**FPL Energy**  
**Seabrook Station**

June 8, 2006  
SBK-L-06131  
Docket No. 50-443

Seabrook Station  
Response to Request for Additional Information Regarding  
Emergency License Amendment Request 06-07  
“Containment Enclosure Emergency Air  
Cleanup System Allowed Outage Time One Time Change”

Enclosure to SBK-L-06131

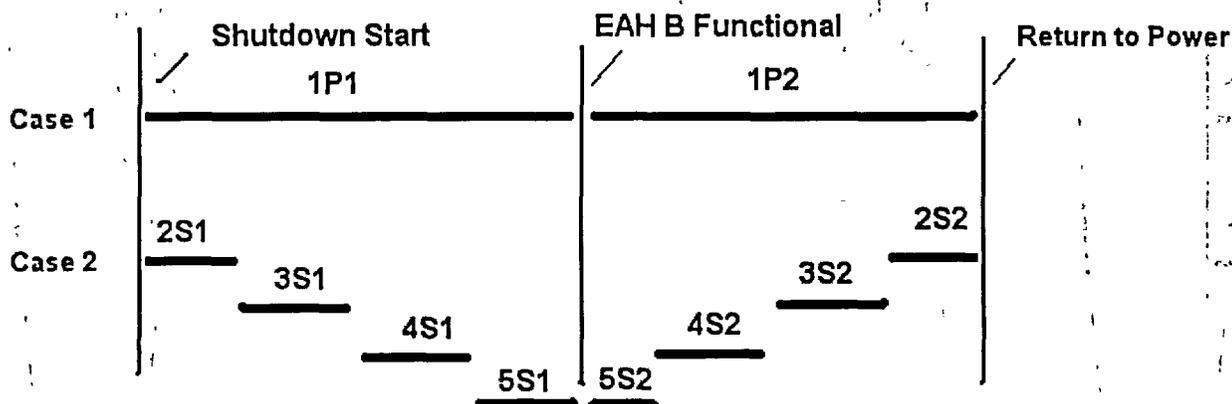
Section 5.0 page 10 provides the quantitative results of the internal events ICCDP analysis, and compares the calculated risk of completing repairs while operating over a 14-day period ( $1.31E-6$  ICCDP), compared to the risk of shutting down to conduct repairs ( $1.5E-6$  ICCDP). The staff is unable to confirm the validity of the analyses. Specifically, the licensee identified that the 14-day ICCDP for on-line repair is  $1.31E-6$ , which represents the delta risk above the nominal full power risk over 14 days. The staff infers that the seven day ICCDP would be 50% of this value, or approximately  $6.5E-7$ . The licensee states (page 10) that if it were to shut down the plant to repair the inoperable EAHF, an additional ICCDP risk of  $2.0E-7$  to  $3.0E-7$  would be incurred for shutting down and returning to power. The staff calculates that the total risk of operating for 7 days, then shutting down to repair the EAHF and return the unit to service, would involve  $8.5E-7$  to  $9.5E-7$  ICCDP, which is inconsistent with the licensee's estimate of  $1.5E-6$ . The licensee is requested to provide a more detailed basis for its ICCDP value of  $1.5E-6$  for shutting down to make repairs.

The integrated, full scope, all modes PRA model was used to calculate the incremental risk assuming the plant stays at power for the 7 day AOT, then shuts down to Mode 5 to repair EAH-FN-31B. The current schedule as of 6/7/06 1100 was used to develop the duration in the various shutdown modes. Note that EAH is required to provide equipment cooling to the RHR pumps in the shutdown cooling mode such that the calculation reflects the impact of EAH-FN-31B out of service throughout Mode 5, in accordance with the schedule.

Two cases were identified. Case 1 is the case for staying at power to repair EAH fan 31B. Case 2 is the case that quantifies the incremental core damage probability for shutting down to repair EAH fan 31B. The starting point (Shutdown Start) for the analysis uses the end of the current action statement. The return to full power was used as the end point for the analysis. Both cases use the same total time. A graphic of the individual configurations quantified is shown below
